Bessborough Housing Development
Blackrock, Co. Cork

Stage 1 Road Safety Audit

March 2022

Figure 2.2.1.1

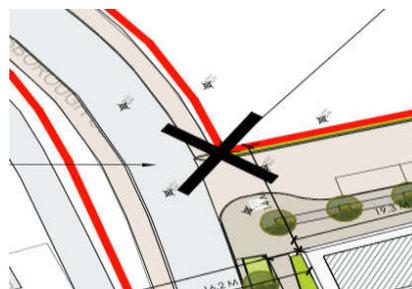
2.2.1. PROBLEM: NO PEDESTRIAN CROSSING ON PUBLIC ROAD AT DEVELOPMENT ENTRANCE

The drawings provided to the audit team do not include the provision of pedestrian crossings on the public road along desire lines. This could lead to collisions between pedestrians and vehicles along the public road.

Provide a safe means for pedestrians to cross the public road.

The radius of the junction tie-in shown is not tangential with the roadside kerb, see Figure 2.2.1.1 above. This could lead to the mis-direction of vehicles entering the minor road resulting in side swiping pedestrians.

Provide a suitable radius at the tie-in between the main road and the minor road.

2.2.1	Yes	Yes	This recommendation has been and implemented as requested – please refer drawing number . <i>SB-2020-106-200-MEADOWS SITE LAYOUT PLAN</i>

2.2.2	Yes	Yes	The turning radius has been adjusted per recommendation. please refer drawing number: <i>SB-2020-106-200-MEADOWS SITE LAYOUT PLAN</i>	
2.2.3	Yes	Yes	The arrangement has been revised to allow for clearer through traffic from the East with provision of safe turning for creche drop off please refer drawing number: <i>SB-2020-106-200-MEADOWS SITE LAYOUT PLAN</i>

Figure 2.3.1.1

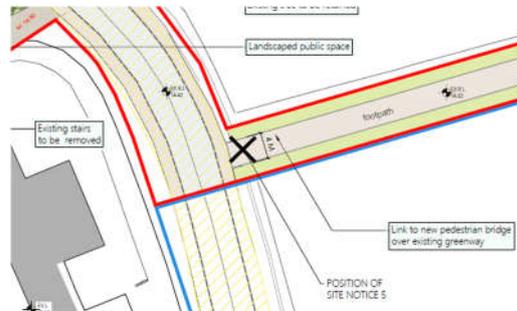
2.3.1. PROBLEM: NO PEDESTRIAN CROSSING ON PUBLIC ROAD

The drawings provided to the audit team do not include the provision of any pedestrian crossing on the public road for pedestrians wishing to access the proposed footbridge. This could lead to collisions between pedestrians and vehicles along the public road.

Provide a safe crossing point for pedestrians to access the proposed pedestrian footbridge.

2.3.1	Yes	Yes	Crossing provision added per recommendation . please refer drawing number: <i>SB-2020-107-200-FARM SITE LAYOUT PLAN</i>	
2.3.2	Yes	Yes	Guard rail provided to push desire line further west - please refer drawing number: <i>SB-2020-107-200-FARM SITE LAYOUT PLAN</i>

Figure 2.3.2.1

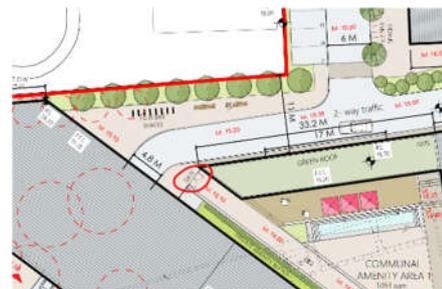
2.3.2. PROBLEM: INSUFFICIENT SIGHTLINES TO THE COMMUNIAL AREA ACCESS GATE

Vehicles approaching the communal amenity area gate from the east do not have clear forward visibility to the gate. This could lead to collisions between vehicles and vulnerable road users, in particular with pedestrians crossing the road to access the bike spaces directly across from the gate.

Design proposals, such as a pedestrian railing, should be considered to block the pedestrian desire line to the bike spaces across the road. Pedestrians crossing at a location further west of this point will have better sightlines to/from vehicles travelling within the development.
